Review of benefit-cost analysis for the EPA's proposed revisions to the 2015 Steam Electric Effluent Limitations Guidelines

Prepared for Earthjustice and Environmental Integrity
Project

January 21, 2020

Synapse
Energy Economics, Inc.

Figure 1: Annualized benefits relative to EPA's 2015 baseline, with and without the VIP program (mid-range)

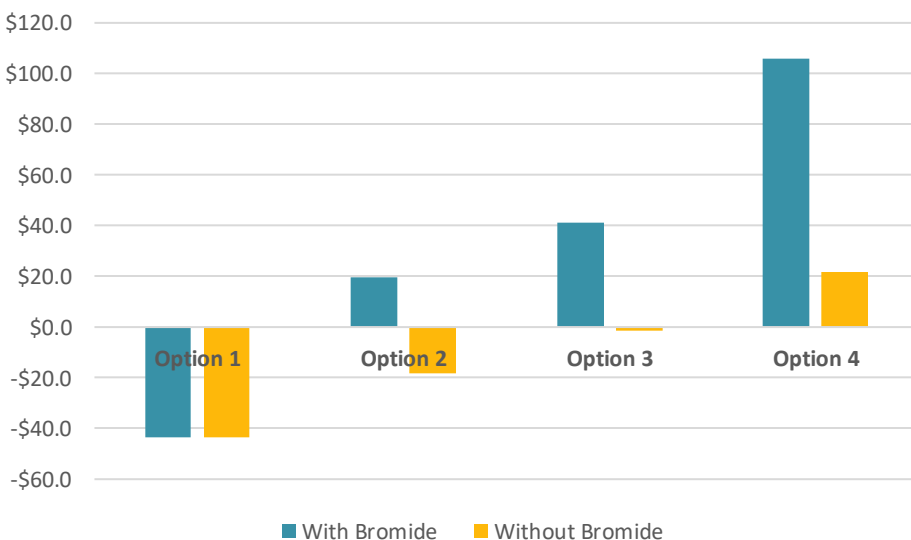
One significant problem with the proposed modifications is that they allow the agency to present the compliance options as though the public has to make a choice between reducing bromide or reducing all other ELG regulated pollutants. A reduction in bromide and bladder cancer is unarguably a good thing. However, it should not be used to justify an increase in all other pollutants. As shown in Figure 1, under the EPA’s proposed Option 2, the changes decrease the net environmental benefits absent the bromide benefits from the VIP program. However, under Option 4, even without the bromide reduction benefits, the proposed modifications will offer net environmental benefits.

Per the EPA, there is significant uncertainty in the bromide impacts from the membrane technologies, and the benefits come from a small number of facilities that would be participating in the VIP program.⁴⁸ Under the original rule, compliance with the VIP program was too expensive, and no plants opted in. Although it is reasonable to attribute the benefits from bromide reduction to the proposed modification, the number of benefits attributed to the current VIP program skews the benefits heavily. This is particularly concerning given the uncertainty in whether the benefits will materialize.

Additionally, the EPA has acknowledged that bromide reduction benefits from VIP program participation stems from only a small number of plants,⁴⁹ but drives the benefits results. The EPA states, “approximately 90 percent of these benefits derive from a small number of steam electric facilities (6 facilities under Option 2, 7 facilities under Option 3, and 17 facilities under Option 4).”⁵⁰ However, the EPA projects that 18 plants will opt in to the VIP program under Option 2. This means that two-thirds of the plants do not actually deliver high bromide reduction benefits (likely because they have significantly smaller wastewater streams or lower bromide levels to begin with) but are still able to defer compliance by five years. Under Option 2, the EPA is essentially trading off the benefits of using a more stringent membrane technology against a delayed compliance deadline for all other pollutants. However, Option 4 (with the removal of the subcategorizations) would not require a trade-off between reduced bromide levels and all other pollutants and should be the recommended compliance option.
